Application number:	LUC60389929
Applicant:	Alexander Williams
Address:	38 Rawene Avenue, Westmere
Proposed activity:	Helicopter take-off and landing

**ATTACHMENT 1 – S92 RESPONSE TABLE**

**LUC60389929 38 Rawene Avenue, Westmere - Further Information Response 1 April 2022**

**Figure 1. 38 Rawene Ave (yellow) and nearest Auckland Council SEA areas (AC GeoMaps).**

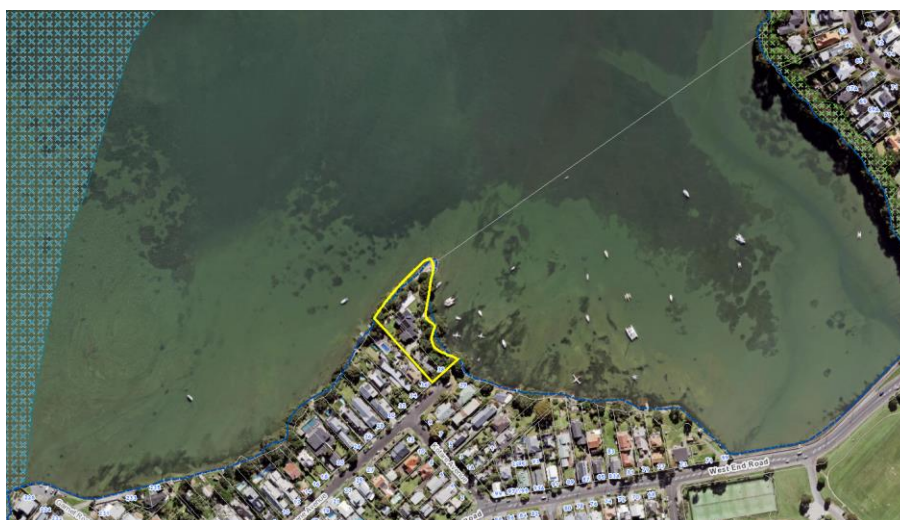
- 1. Please provide an ecological assessment prepared by a suitably qualified professional that identifies potential and actual effects on the ecological values of the area resulting from helicopter movements to and from the site.*

*Of note is the rock shelf on the point north of the proposed helipad location, which is a known significant local roost for both variable and pied oyster catchers; however, all relevant ecological impacts should be identified and assessed.*

The cliff area and the coastal marine area near the cliff are not subject to a Significant Ecological Area (SEA) overlay, with the closest SEA-Marine area located to the west and associated with Meola Reef.

Figure 4. Air Bus H130T2 measured at 40m from helipad

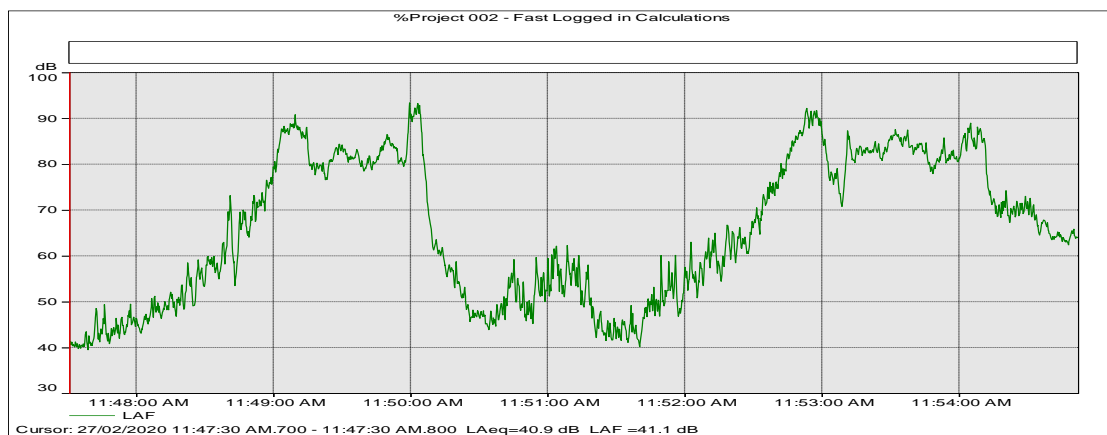
5. Please provide the  $L_{Aeq}$  and time duration for the measurement at 40m, as shown in Figure 4. [As reproduced below]

The total time of this trace is 10 minutes 31 seconds and the total noise level for the activities shown on this trace is 80.8dB  $L_{Aeq}$ . This trace includes the noise of the helicopter manoeuvring just after take-off and just prior to landing plus an aircraft taxiing past between the flights.

**1 HELIPDA LOCATION PLAN**  
A2-18 Scale 1:500

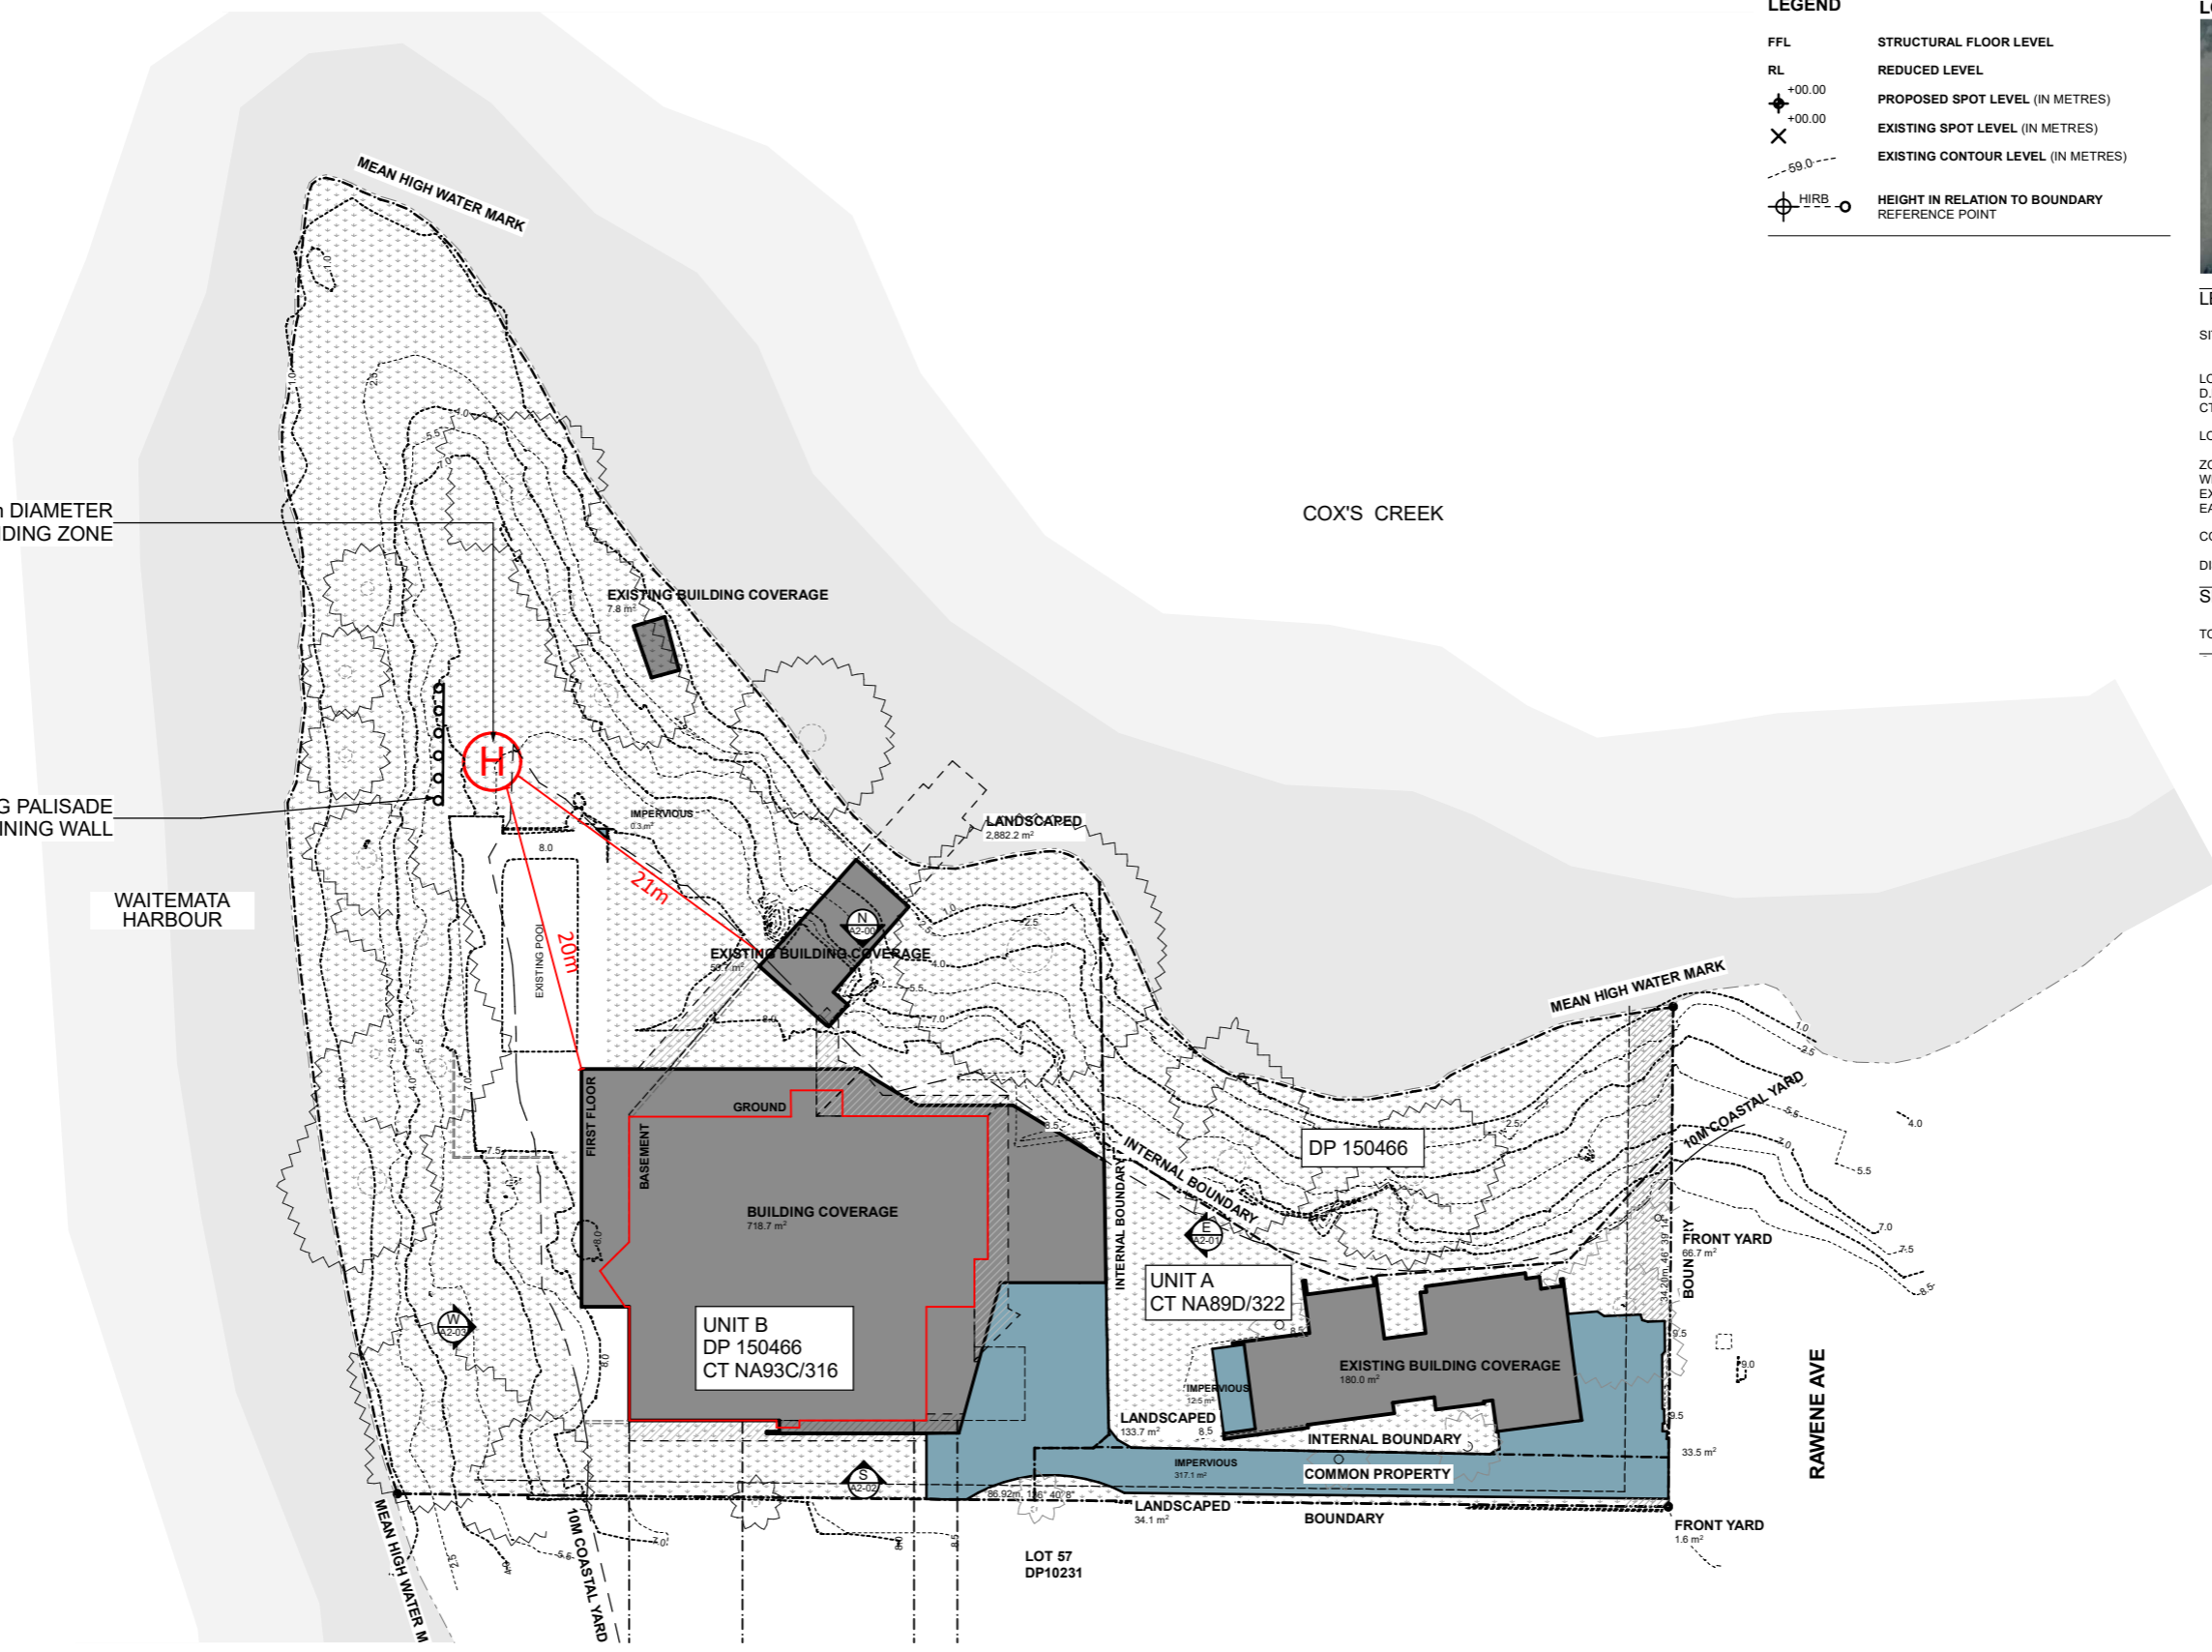
Request	Response/comments
		the period given (19 secs. for a departure to 500ft. and 45 secs. for an approach from 500ft) is infinitesimal.
9.	<p>Please provide further detail of the proposed helipad location, including:</p> <ul style="list-style-type: none"><li>a. A plan identifying the helipad location (pictures with the helipad location outlined would also be helpful);</li><li>b. The RL of the helipad;</li><li>c. The distance from an identifiable point of the dwelling approved under BUN60373967 and from the nearest coastal planting proposed under coastal consent CST60383790 (BUN60383789).</li></ul> <p>This information is required in order to ensure that the noise modelling provided is accurate and that any future flights are in accordance with the predicted noise levels.</p> <p>It is recommended that the proposed helicopter coordinates are checked to confirm these are accurate and in accordance with the above.</p> <p><i>NB: I note that building consent BCO10329873 grants the construction of a retaining wall near the coastal boundary and the apparent helipad location. If earthworks (cut or fill)</i></p>	<p>Please find attached a plan prepared by Ponting Fitzgerald Architects which shows the helicopter landing pad location. The area is shown as a 4m diameter circle where the helicopter will land. It is clear of the planting authorised under CST60383790 / BUN60383789. The area is at 8m RL.</p> <p>The dimensions from the proposed dwelling are noted on the plans and this is considered to provide the requested detail.</p> <p>The co-ordinates of the helipad are approximately: NZTM: 1753294E, 5920376N</p> <p>The final location can be confirmed via a surveyor as a condition of consent should that be considered necessary.</p>
